Car Stereo  
**Service Bulletin**

**Model:** CDX-5060

**No.** 323

**Subject:** No Functions Due To Main Board/ Display Board  
Incompatibility.

DISPLAY BOARD (Side B)

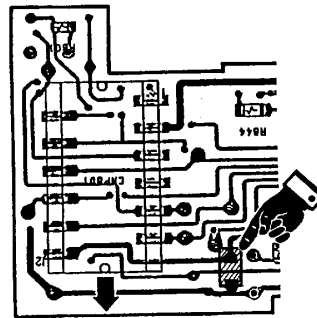
After replacing the Main Board or the Display Board, the unit may not respond to any function buttons.

This problem may be caused if a **Main Board** having a silk-screened suffix of -12 is connected with a **Display Board** having a silk-screened suffix of -11. In this case, normal operation can be restored by adding a jumper resistor to the -11 Display Board as shown below.

REF	DESCRIPTION	PART NUMBER
JR801	JUMPER RESISTOR, 0 OHM	1-216-295-00
